NEWMAR CORPORATION WARRANTY DEPARTMENT

RECALL SERVICE BULLETIN

DATE ISSUED	MODEL YEAR(S) AFFECTED	RSB #
3/23/2017	2015-2017	463 Amended

How to Add the Ignition Lock Out Feature to a Power Wheelchair Door

Remove relay and harness if needed.

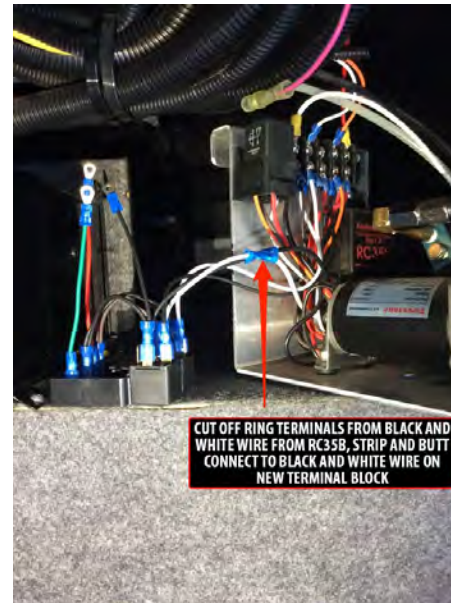
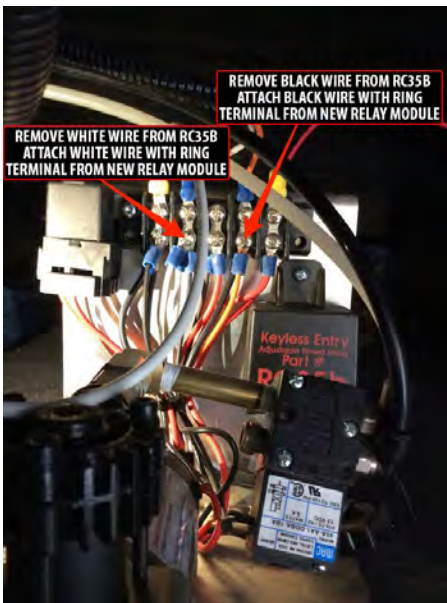
If the coach has had a relay installed to interrupt the main power wire (as previously outlined in the prior recall instructions), then it will need to be removed to provide constant power to the terminal block. If the relay was not installed, skip the removal outlined below.

To remove it, disconnect the relay from the ground and ignition wire, and then reconnect the main power wire together with a yellow butt connector. Discard the previously installed relay and harness, then reconnect the power wire at the end of the following procedure.

Install the new module.

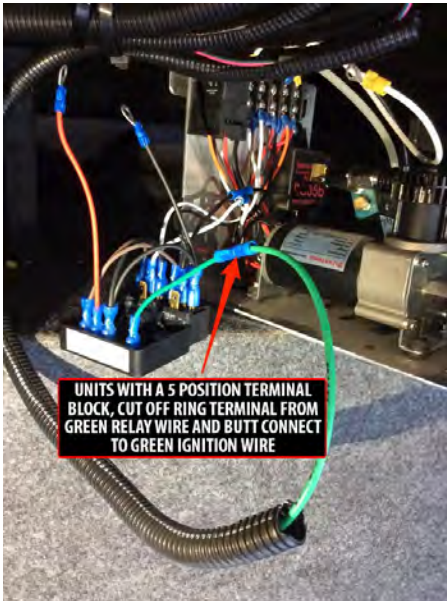
Disconnect the black and white wires from the RC35B terminal block.

Cut the two ring terminals off of the black and white wire from the RC35B, and then strip them back.

Connect the black and white wires to the new relay with butt connectors (black-to-black and white-to-white).

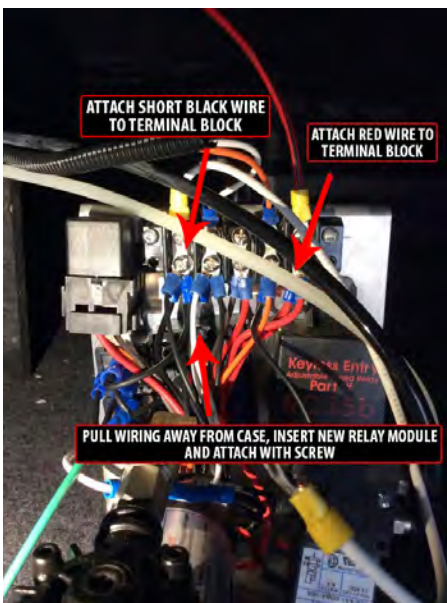
Connect the black wire with a ring terminal from the new relay to the terminal block (where the black wire was previously removed).

Connect the white wire with a ring terminal from the new relay to the terminal block (where the white wire was previously removed).

On coaches equipped with a 6-position terminal block, hook up the green wire to the open space in the terminal block.

Then hook up the green ignition wire to the top terminal in same space on the terminal block.

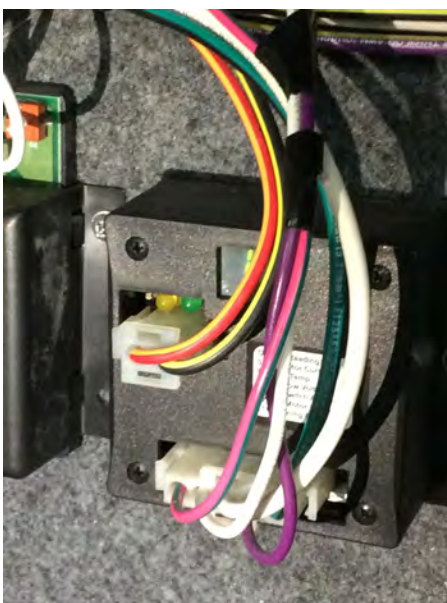
On coaches equipped with a 5-position terminal block, cut the ring terminal off the new relay. Then strip the insulation and connect it to the green wire using a blue butt connector.

Move the wiring around, and install the new relay delay assembly against the metal housing under the terminal block.

Secure it with a one inch self-tapping screw, making sure you do not pinch the other wiring.

Hook up the red wire with a ring terminal from the new relay module to the red wire located at the terminal block connected to the main power wire.

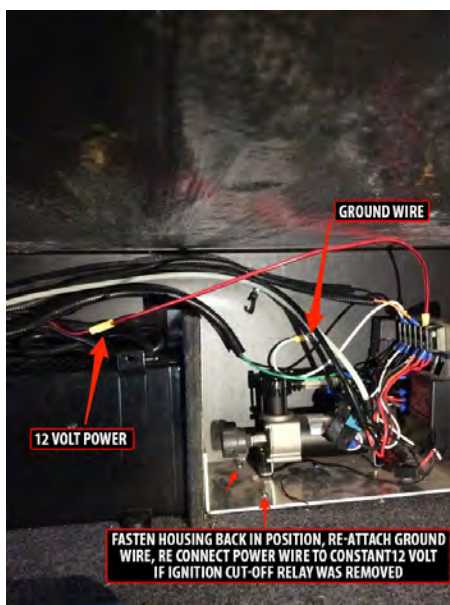
Hook up the short black wire with ring terminal to the terminal position with ground wires.

Locate the pink wire with a green stripe (ignition wire) connecting to the slideout modules nearby.

Trace the wire back in loom to find a convenient spot to connect the green wire from the terminal block or the green wire on the new delay module.

Modify the length of the green wire (if necessary). The length will depend on where you can attach it to the pink wire with the green stripe (ignition wire).

Wiring Diagram

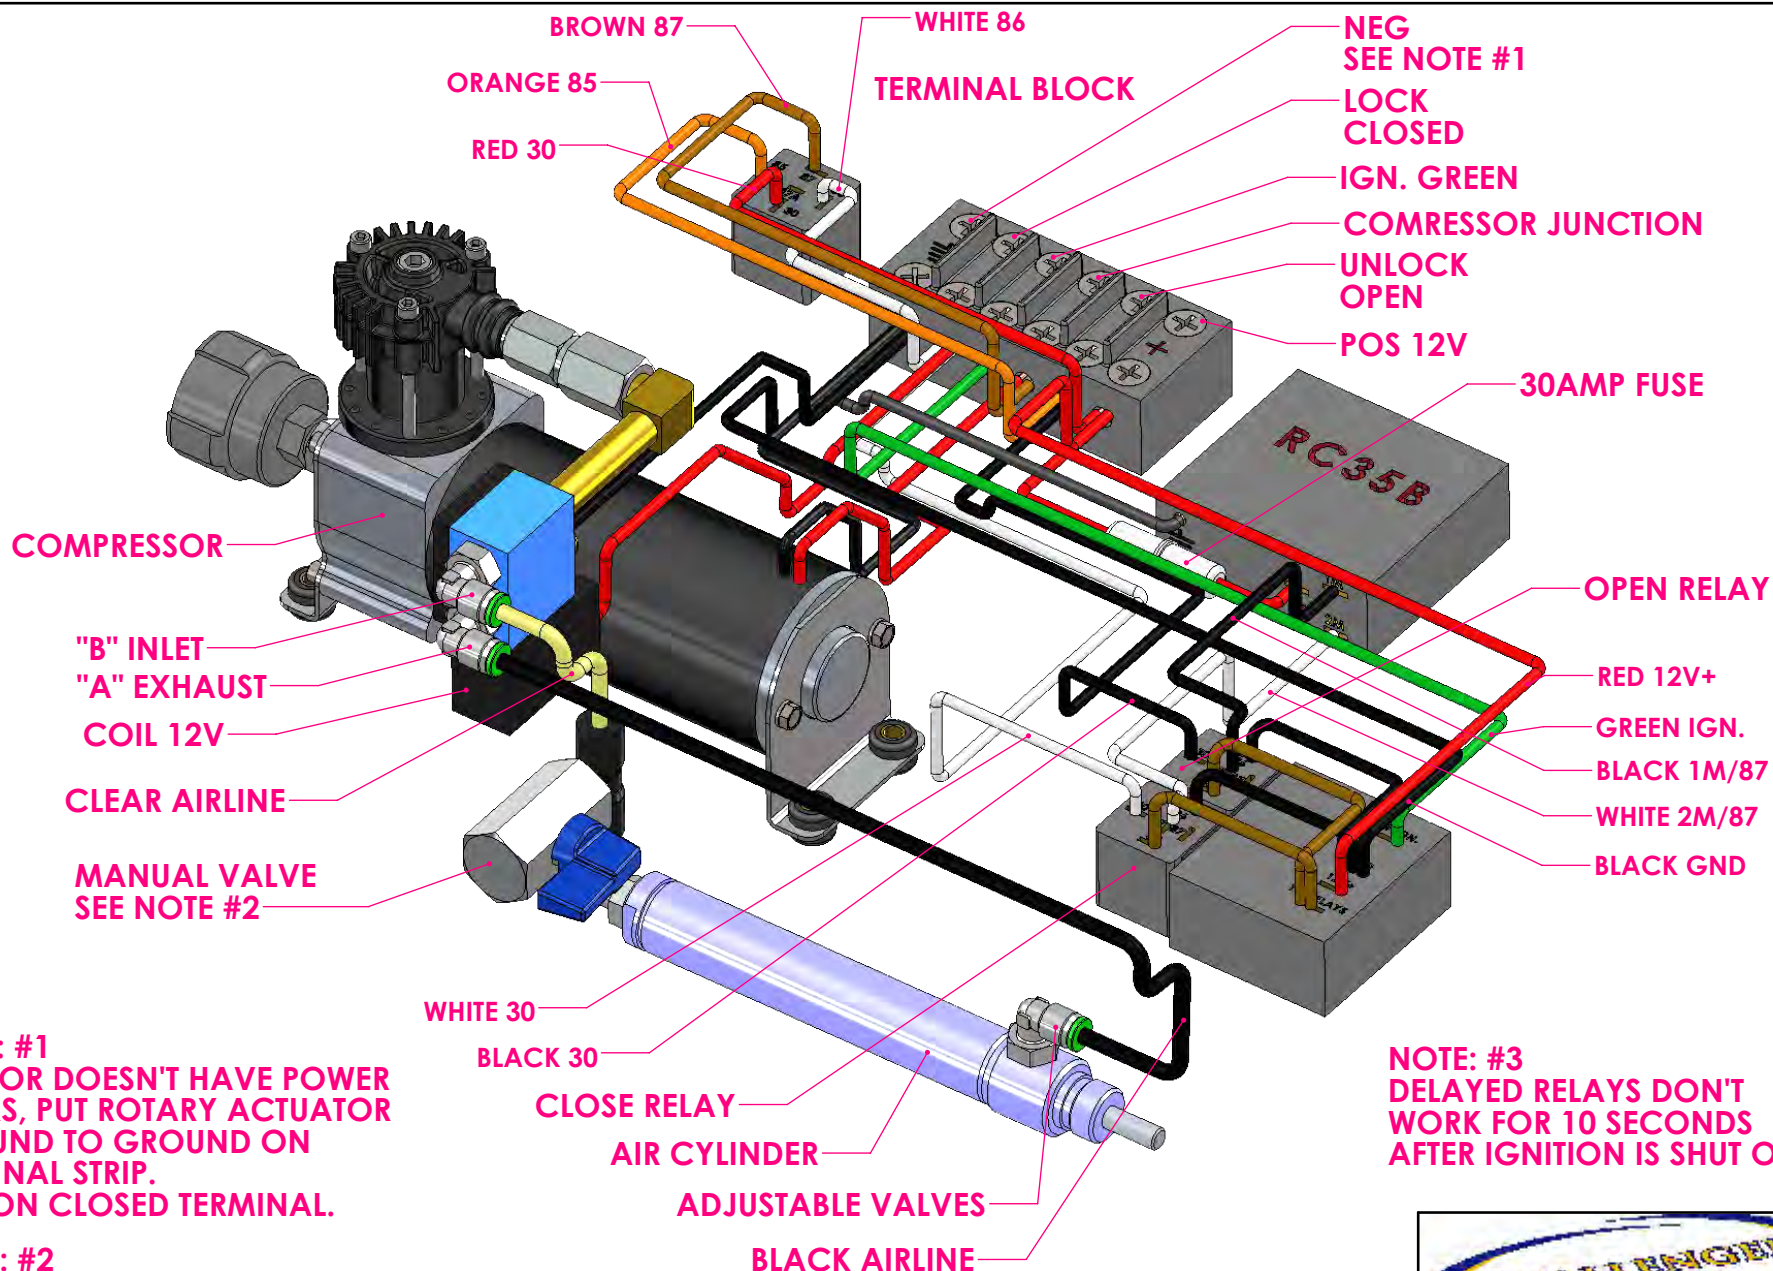
NOTE: #3
DELAYED RELAYS DON'T
WORK FOR 10 SECONDS
AFTER IGNITION IS SHUT OFF.
